**Town of Kittery Maine
Town Planning Board Meeting
September 12, 2019**

ITEM 4 – 60 Route 236 – Preliminary Site Plan Acceptance Review

Action: Accept or deny application. Schedule Public Hearing. Owner/applicant Washburn Realty Group, LLC requests consideration of a preliminary site plan for a 4,603 sf 2-story building on a 73,330 sf lot at 60 Route 236 (Tax Map 29, Lot 14) in the Commercial (C-2) Zone. Agent is John Chagnon, Ambit Engineering, Inc.

SITE LAYOUT PLAN
C3

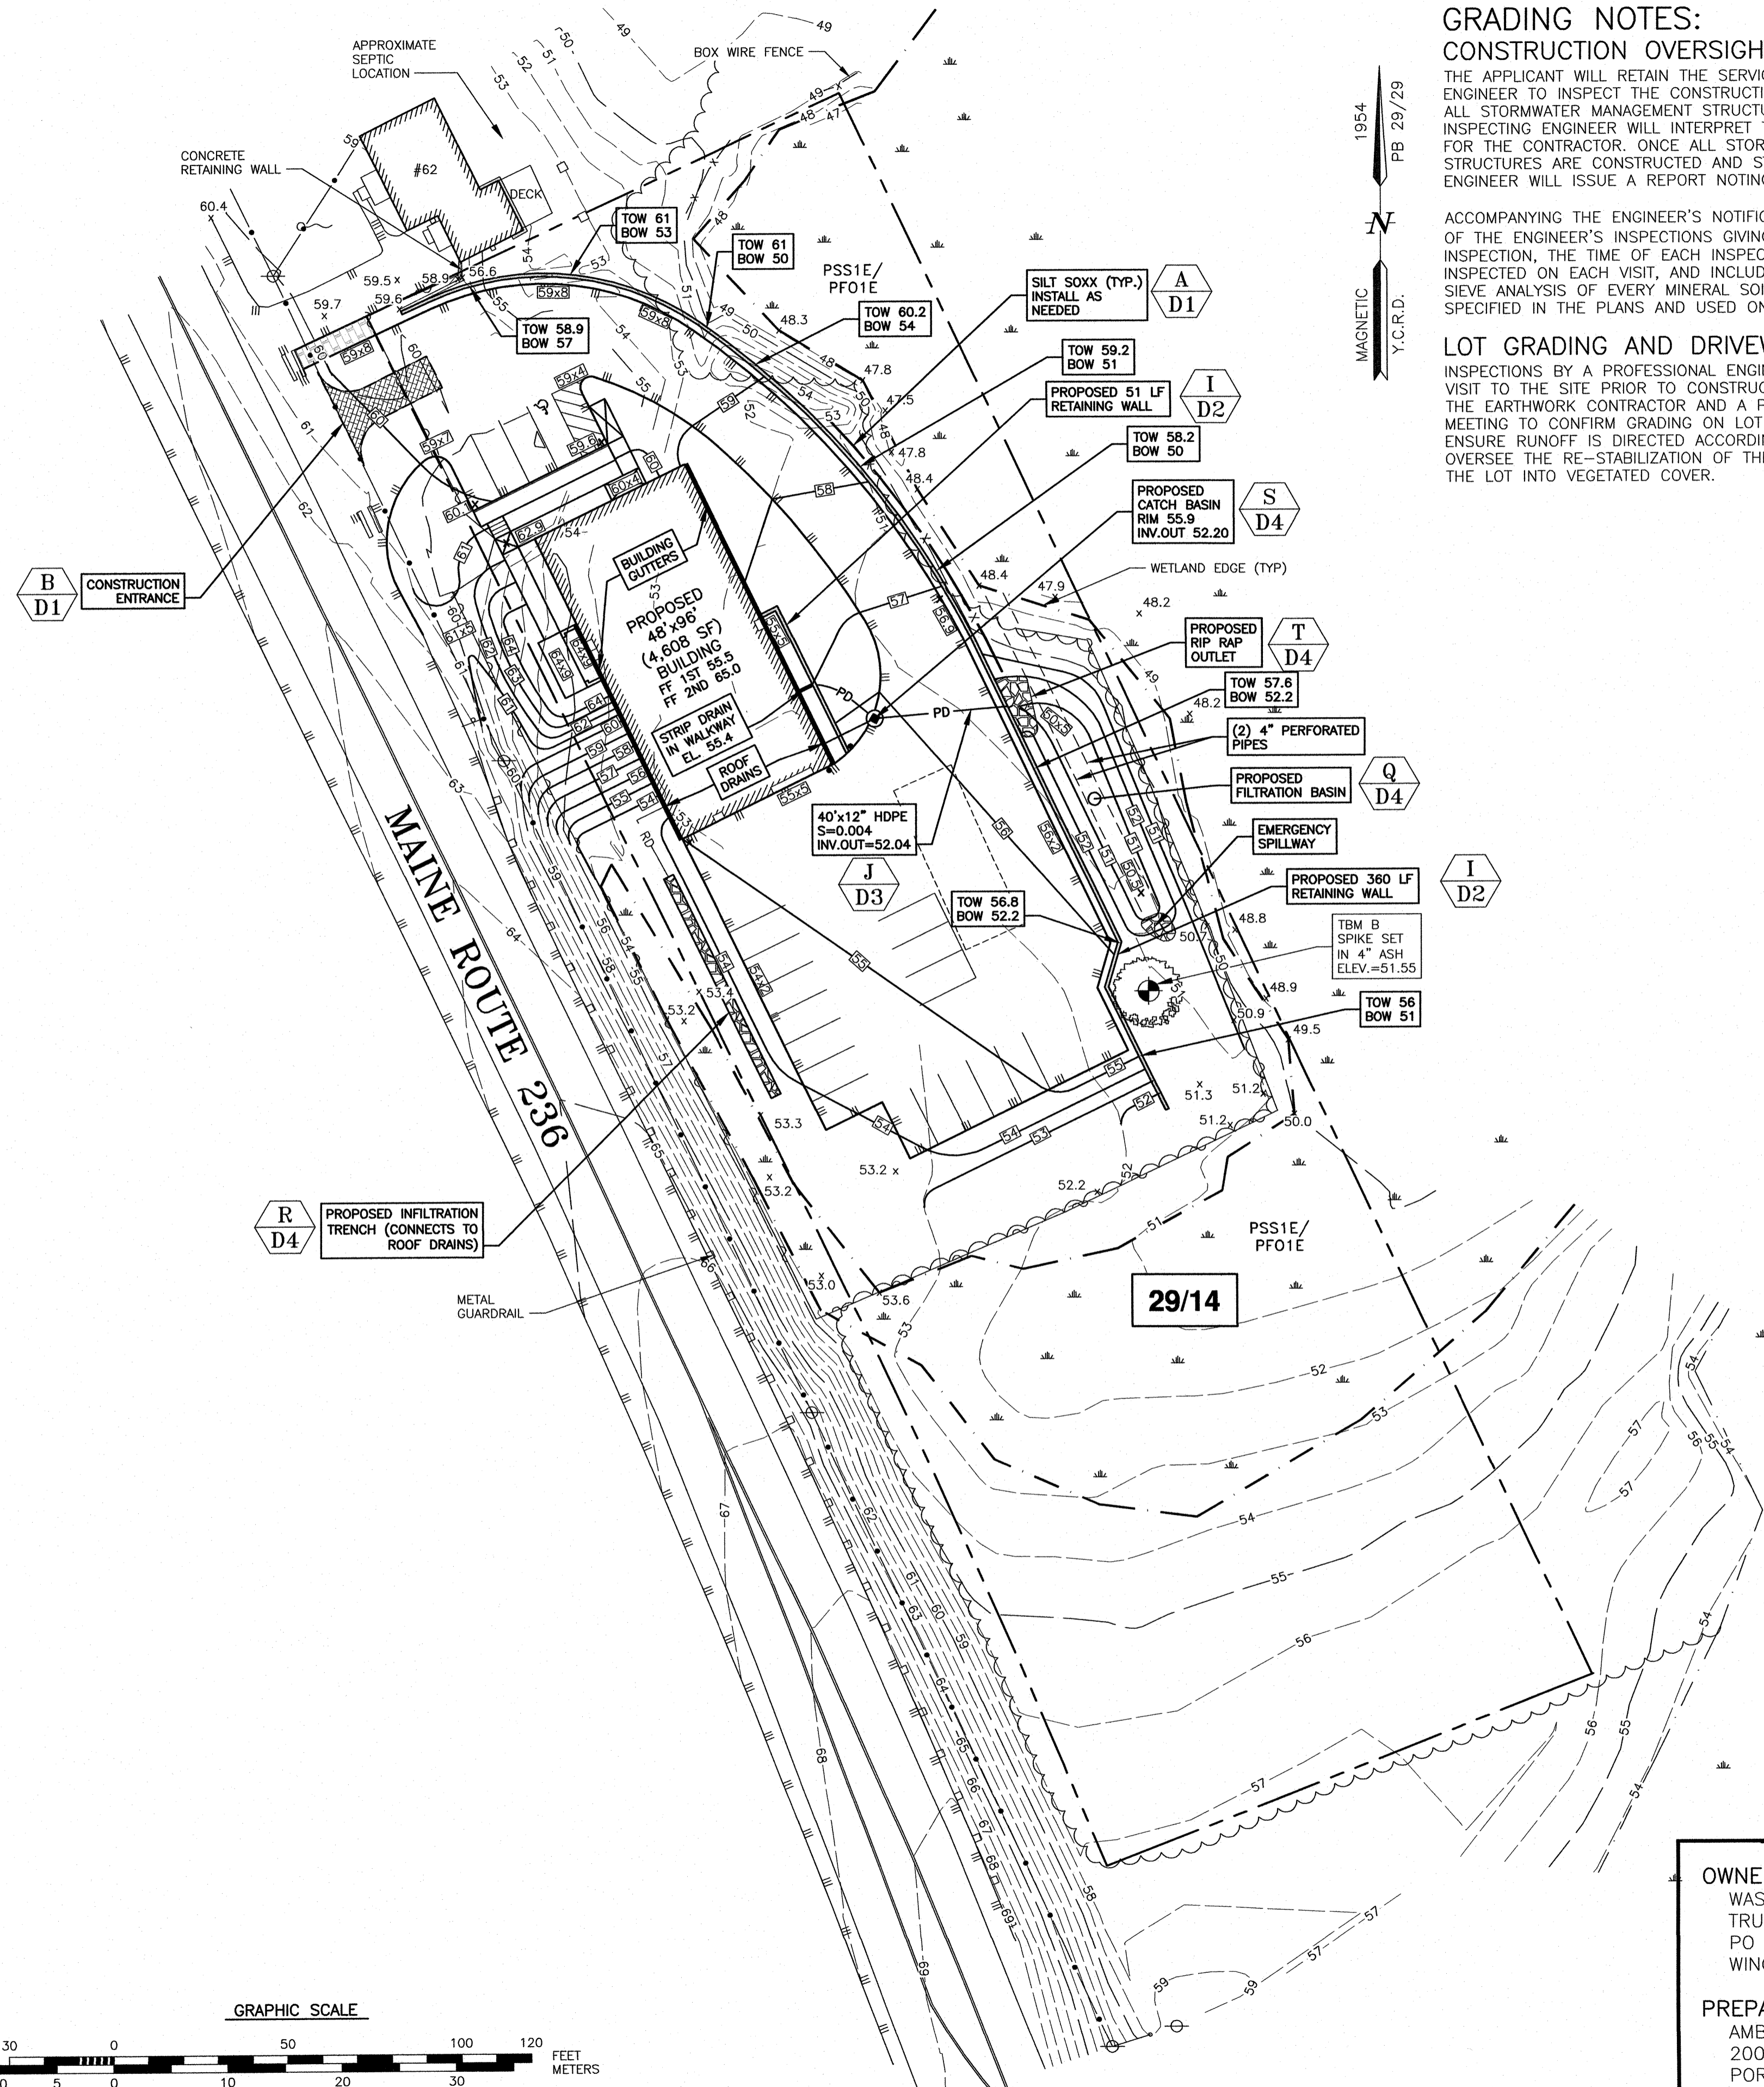
The site layout plan details the required parking. Although the proposed use(s) is not specifically listed in the chart, it is being proposed by the applicant as a warehouse and storage use. The requirement based upon that use category is 19 spaces but this does not include the showroom, which indicates a retail use. The size of the showroom is still TBD but is estimated to be 1,200 +/- square feet, which would require approximately 7 additional parking spaces if calculated for retail. However, Section 16.8.9.4.C allows for the Planning Board to determine the parking requirements and projected development use intensity for uses that are not specifically covered in the code.

The applicant is proposing improvements for vehicular access and circulation. The front entrance driveway will be significantly narrowed and relocated. The new driveway for truck deliveries and parking is to the rear and will require a retaining wall along most of its length to hold up the roadway. A small section of cobblestone is proposed at the entrance along the northerly property line to provide tactile separation with the abutting driveway which is right on the property line.

Accessible parking spaces and ramps are shown and detailed on the plan. The ramps are proposed to be screened and buffered with landscaping.
